**Project Address:** 310-402 Cottage Grove Road, 904 Dempsey Road  
**Application Type:** Revised Preliminary and Final Plat  
**Legistar File ID #** 32131  
**Prepared By:** Heather Stouder, AICP, Planning Division  
Report Includes Comments from other City Agencies, as noted

**Requested Action:** The applicant requests approval of a revision to a preliminary and final Royster Corners plat to subdivide the 32.9-acre property for the creation of 60 lots totaling 22.8 acres, 3 outlots for stormwater management and greenspace totaling 4.4 acres, and the dedication of public streets within.

**Proposal Summary:** The applicant proposes a revision to the approved subdivision of the property which would remove a street connection. The proposed revision is concurrent with three development proposals also before the Plan Commission.

**Figure 1: Royster-Clark Special Area Plan – Recommended Future Land Use**

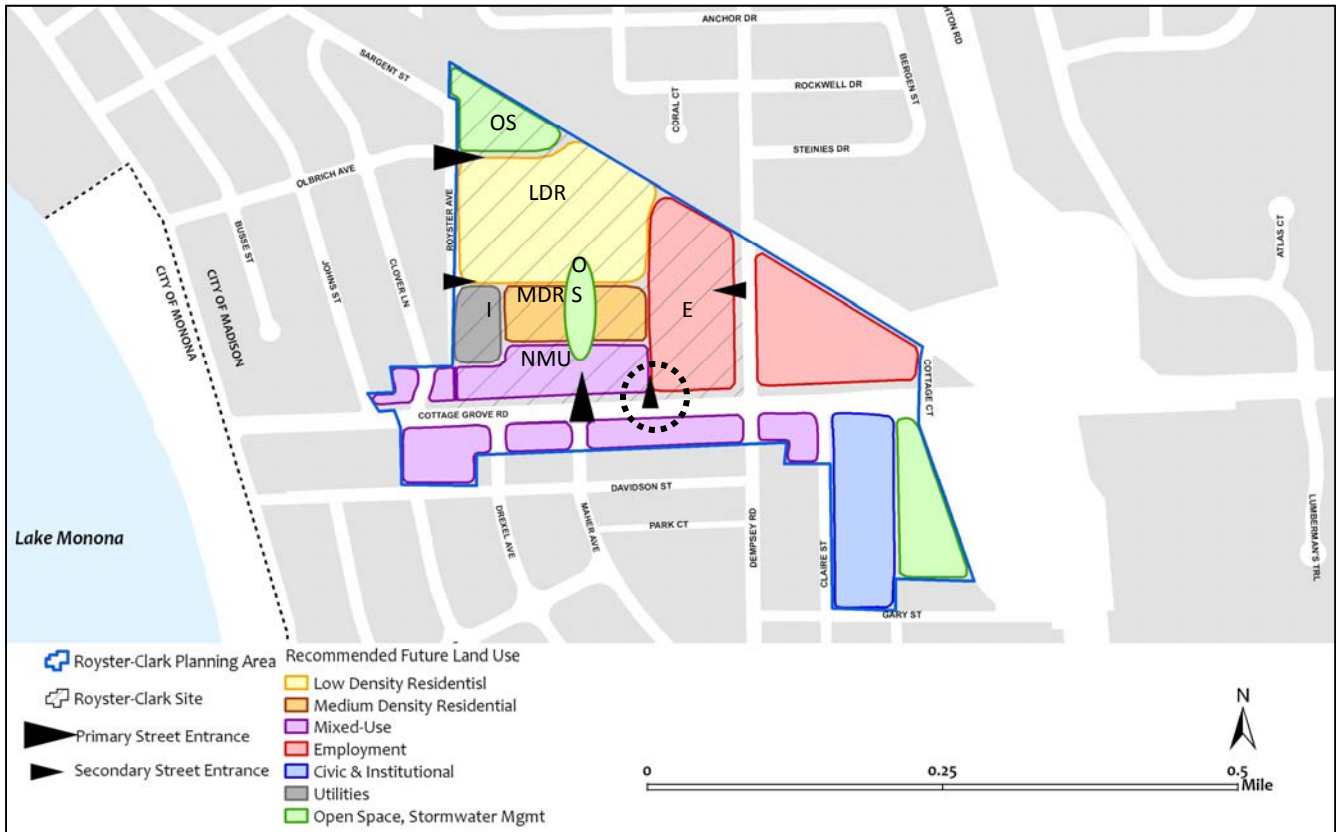
The proposed revisions are consistent with the [Royster-Clark Special Area Plan](#)<sup>1</sup>, adopted in October 2009, which recommended the street that is proposed for removal as a secondary or optional street entrance (see area within dashed circle below).

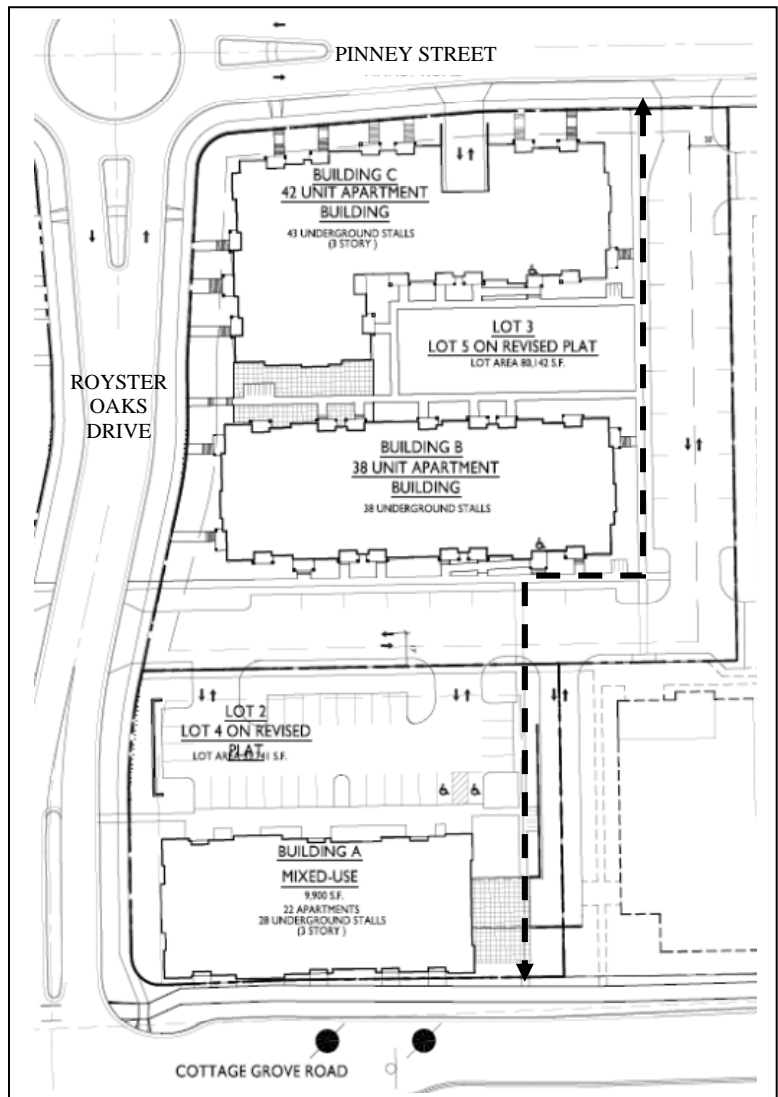
Staff carefully considered the proposal to eliminate this street, which would have been located mid-block between Royster Oaks Drive and Dempsey Road, separating the mixed-use and employment portions of the site. Without a street, the length of the resulting block between Royster Oaks Drive and Dempsey Road is approximately 600 feet, which is the length of a typical urban block. If this stretch were significantly longer, it would be difficult to move forward without a street connection here. However, staff believes that so long as a north-south pedestrian connection is maintained somewhere between Royster Oaks Drive and Dempsey Road through this area to provide more direct access to the commercial, employment, and residential uses and to any future development oriented to Pinney Street, the north-south street proposed for removal is not needed. Staff

notes that the applicant has already provided a pedestrian connection to meet this need within the development proposals currently before the Plan Commission (see graphic below).
